Docket Number:	97-AFC-02C
Project Title:	Sutter Power Plant Application for Certification
TN #:	201868
Document Title:	Calpine's Responses to CEC Staff Formal Data Requests 37 through 40
Description:	N/A
Filer:	Sarah Madams
Organization:	CH2M HILL
Submitter Role:	Applicant Consultant
Submission Date:	3/12/2014 4:07:03 PM
Docketed Date:	3/12/2014

Subject: Sutter Energy Center (97-AFC-2C), Responses to Formal Data Requests 37 through 40

Sutter Energy Center

Response to Informal Data Requests 37–40

FIGURE 3-R
Wetland Features in the SEC Project Area
Sutter Energy Center

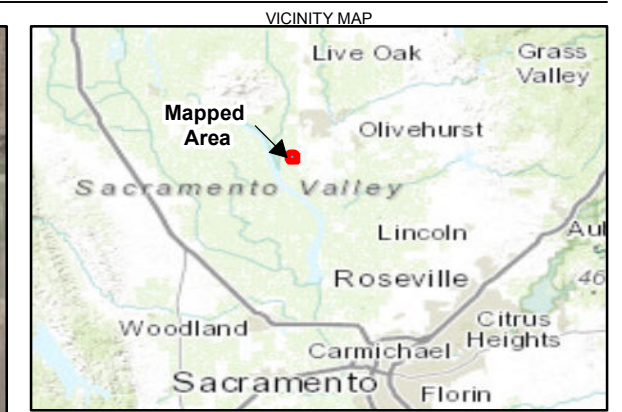
39. *During our January 16, 2014 site visit, it was unclear where the laydown and parking area for the proposed expanded project would be. Please identify the laydown/parking area that will be used.*

40. *None of the figures provided with the SEC's "Preliminary Delineation of Wetlands and Other Water Bodies, Sutter Energy Center, Sutter County, California" or in the SEC petition section entitled, "Environmental Analysis of Proposed Project Modifications," delineates the exact area that will be disturbed/lost due to construction of the expanded ACC. The SEC site is shown with wetland resources mapped, but no indication on the map of the exact area disturbed/lost for the proposed project overlain on the wetland resources map. Please provide a revised Figure 3 from the Wetlands Delineation report showing the area to be disturbed/lost due to the proposed project modifications. Please include a table of the acres of potential wetland that will be disturbed/lost if the proposed project is built.*

Response: Figure 3-R provided as a response to Data Request 40 identifies the location of the laydown and parking areas to be used during these modifications. These areas were also used for this purpose during construction of the SEC.

Response: A revised figure from the Wetlands Delineation Report is provided as Figure 3-R, and identifies the location of the expanded ACC modifications, and includes the area that will be lost/disturbed due to the proposed project modifications. Approximately 0.025 acres of potential wetland (SW-002) would be lost.
